Office Action Summary

10/581,908

KOHCHI ET AL.

DETAILED ACTION

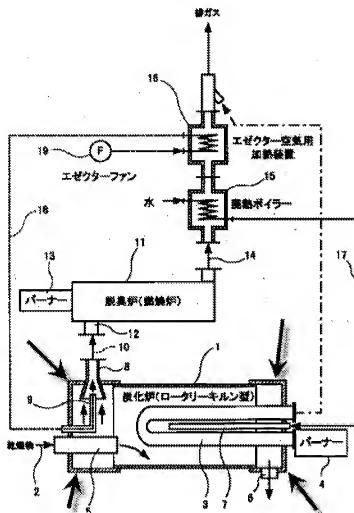
2. Claim 13 is rejected under 35 U.S.C. 103(a) as being unpatentable over JP 2002-364816 to Osamu et al in view of JP 2002-194362 to Susumu et al. '816 discloses a carbonization apparatus which comprises: a drying carbonization furnace (1) for drying waste material (2) by heat transmission caused by bringing said waste material (2) into direct contact with overheated steam introduced thereinto to carbonize said waste material and discharging spent steam which is no longer required; a deodorizing furnace (11) for deodorizing impurities contained in the spent steam discharged from said drying carbonization furnace (1) by heating the steam and discharging the steam reaching a high temperature; and a waste heat boiler (15) for generating steam from water heated with the high-temperature steam discharged from said deodorizing furnace (11).

3. '816 fails to disclose a high-temperature steam generator for generating, from the steam introduced therein, the overheated steam to be fed to said drying carbonization furnace. '362 teaches a carbonization apparatus with a high-temperature steam generator (2) for generating, from the steam introduced therein, the overheated steam to be fed to a drying carbonization furnace (3). It would have been obvious to one skilled in the art at the time of invention to combine the apparatus disclosed by '816 with the teaching of '362 because such a combination would have produced the added benefit of a more efficient process of generating the superheated steam for the carbonization furnace.

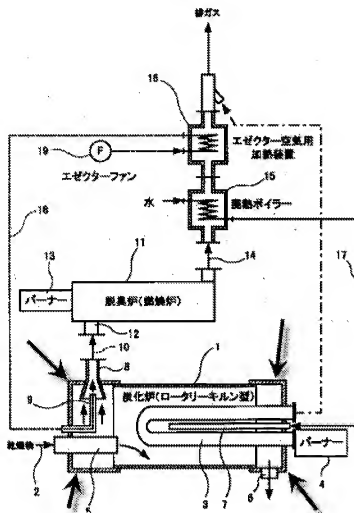
6. Claims 14-17, 20 and 23 are rejected under 35 U.S.C. 103(a) as being unpatentable over '816 in view of '362 as applied to claim 1 above, and further in view of JP 55003510 to Nagao. '816 further discloses a drying carbonization furnace provided with a cylinder shell (represented by arrows in Fig. reproduced below; hereafter "arrow") having a waste intake port (5) for introducing waste material (2) to be treated, a cylinder part (1) for stirring and moving the waste material, an exhaust port (6) for discharging the waste material, and a steam inlet port (7) for introducing overheated steam or spent steam tangentially from the outside of said cylinder part (1) to the inside of said cylinder part (1), wherein said cylinder shell (arrow) is provided with a plurality of steam inlet ports (7, each hole from which steam can be releases is a port), wherein said cylinder shell (arrow) is provided with a steam discharge port (8) from which the spent steam after heating the waste material (2) in said cylinder shell (arrow) is discharged in a direction tangent to the inner surface of said cylinder part (1) from the inside of said cylinder part (1) to the outside of said cylinder part.

7. '816 fails to disclose rotatable stirring blades for stirring and moving the waste material in said cylinder shell, wherein a steam inlet port is formed to introduce the overheated steam or spent steam in the same direction tangent to the inner surface of said cylinder as the rotation direction of said stirring blades. '510 teaches a rotary carbonization furnace with stirring blades (9, 10) for stirring and moving waste material in a cylinder shell. The steam inlet port (7) of '816 is formed such that it introduces the overheated steam in the same direction tangent to the inner surface of said cylinder as

the rotation direction of said stirring blades. It would have been obvious to one skilled in the art at the time of invention to modify the carbonization furnace of '816 with the stirring blades of '510 because such a combination would have produced the added benefit of a more thoroughly carbonized end product.

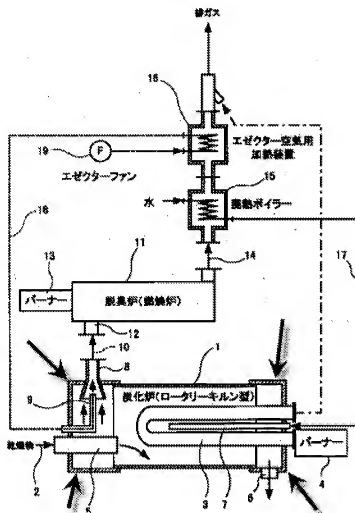
8. Claims 28-31, 34 and 37 are rejected under 35 U.S.C. 103(a) as being unpatentable over '816 in view of '362 and '479 as applied to claim 27 above, and further in view of JP 55003510 to Nagao. '816 further discloses a drying carbonization furnace provided with a cylinder shell (represented by arrows in Fig. reproduced below; hereafter "arrow") having a waste intake port (5) for introducing waste material (2) to be treated, a cylinder part (1) for stirring and moving the waste material, an exhaust port (6) for discharging the waste material, and a steam inlet port (7) for introducing overheated steam or spent steam tangentially from the outside of said cylinder part (1) to the inside of said cylinder part (1), wherein said cylinder shell (arrow) is provided with a plurality of steam inlet ports (7, each hole from which steam can be releases is a port), wherein said cylinder shell (arrow) is provided with a steam discharge port (8) from which the spent steam after heating the waste material (2) in said cylinder shell (arrow) is discharged in a direction tangent to the inner surface of said cylinder part (1) from the inside of said cylinder part (1) to the outside of said cylinder part.

9. '816 fails to disclose rotatable stirring blades for stirring and moving the waste material in said cylinder shell, wherein a steam inlet port is formed to introduce the overheated steam or spent steam in the same direction tangent to the inner surface of said cylinder as the rotation direction of said stirring blades. '510 teaches a rotary carbonization furnace with stirring blades (9, 10) for stirring and moving waste material in a cylinder shell. The steam inlet port (7) of '816 is formed such that it introduces the overheated steam in the same direction tangent to the inner surface of said cylinder as

the rotation direction of said stirring blades. It would have been obvious to one skilled in the art at the time of invention to modify the carbonization furnace of '816 with the stirring blades of '510 because such a combination would have produced the added benefit of a more thoroughly carbonized end product.
